Docket Item # 2  
BAR CASE # 2010-0073

BAR Meeting  
May 26, 2010

**ISSUE:** Alterations

**LOCATION:** 320 North Patrick Street

Figure 4. Rear Elevation of Current Proposal

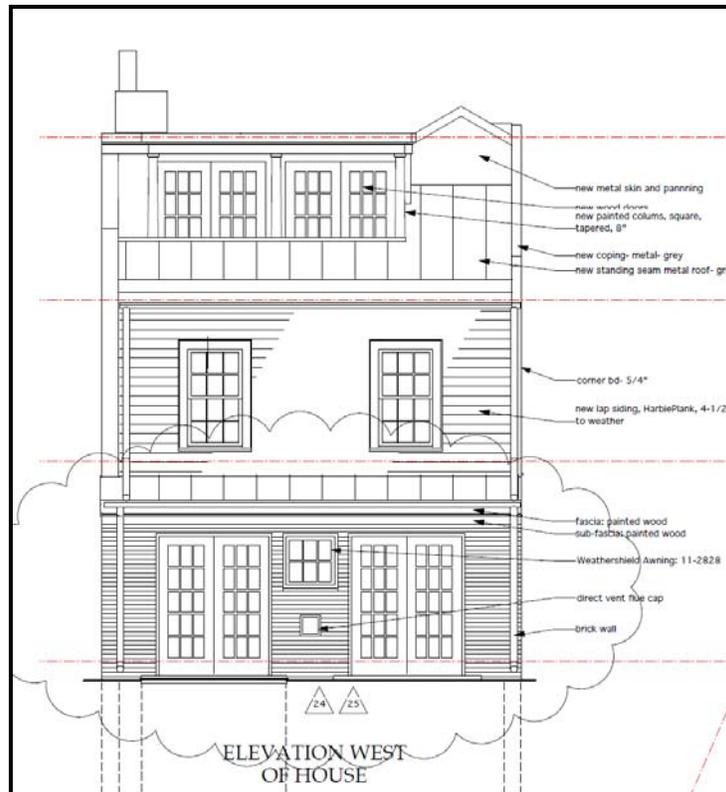
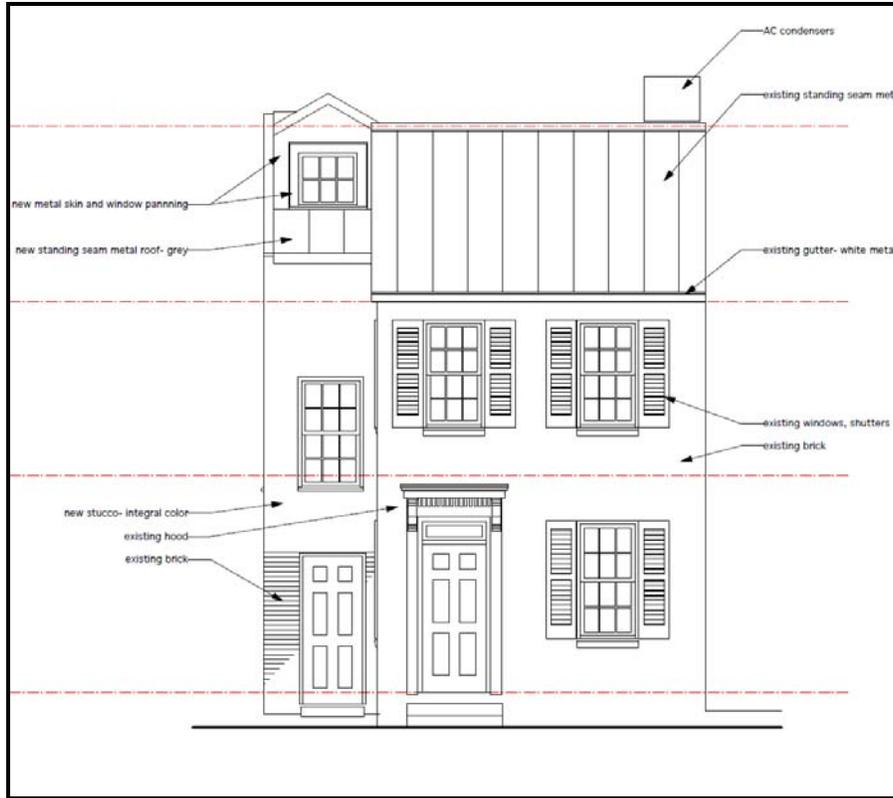
1. Change approved design details on the rear elevation (Hardi-plank siding, pilasters and entablature) and replace with brick walls and a painted wood fascia.
2. Replace a full-length wood window on the first floor with a wood, awning window and a direct vent fireplace unit. (The only visible detail on the exterior will be the flue cap. The fireplace unit will be housed inside the addition and not protrude into the rear yard.)

**Figure 6. Front Elevation of Current Proposal**

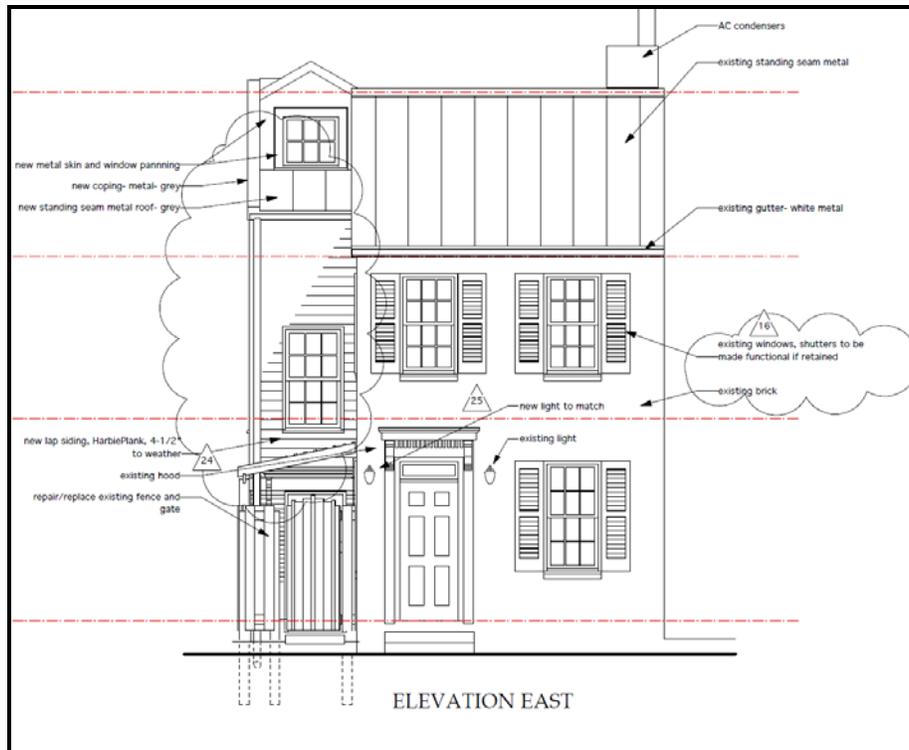
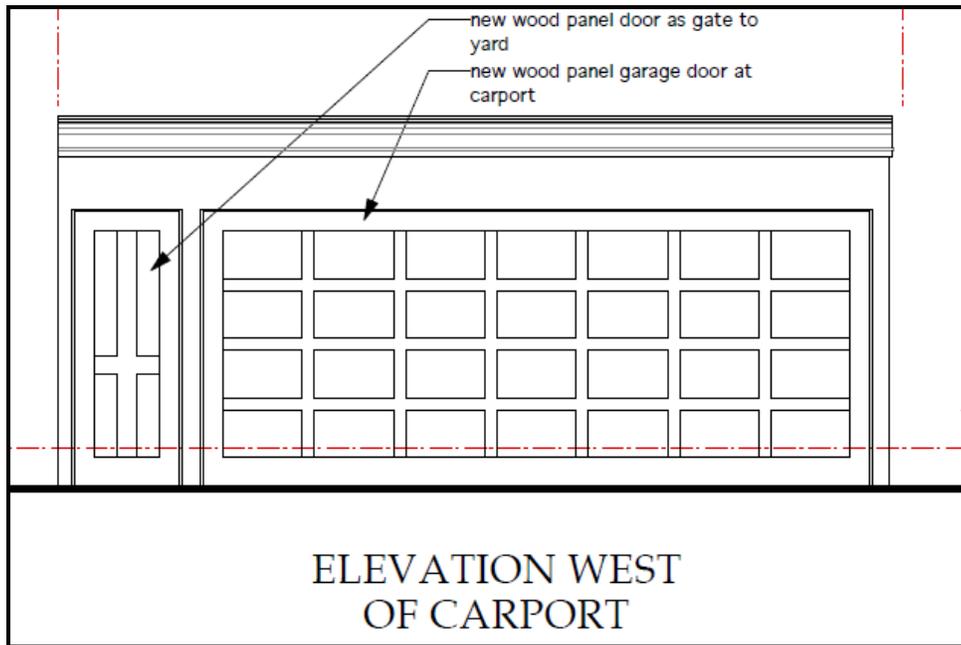
1. Change approved wall fabric from stucco to Hardi-plank 4-1/2" lap siding.
2. Repair and replace existing 6' high fence and gate

Figure 7. Carport - 2008 Approval

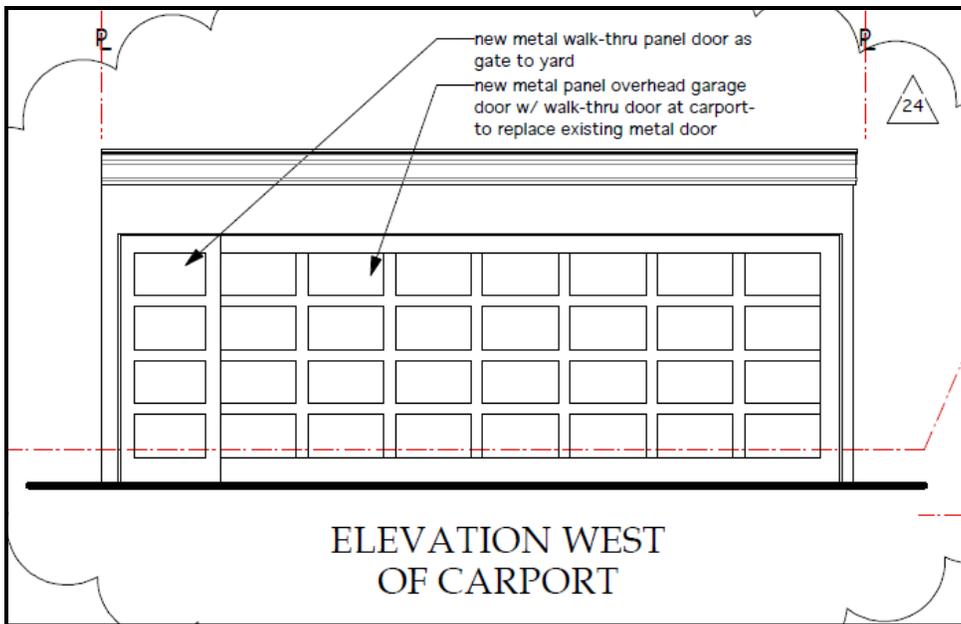
1. Replace approved wood, four-panel door with a new, horizontal four-panel metal door.
2. Replace approved wood, panel overhead garage door with a new, metal panel overhead garage door.

That the applicant provide manufacturer's specifications for the proposed new window and doors on the addition and carport for Staff to confirm that the window will be painted wood to match the details of the previously approved windows and that the metal garage doors be a smooth painted finish.
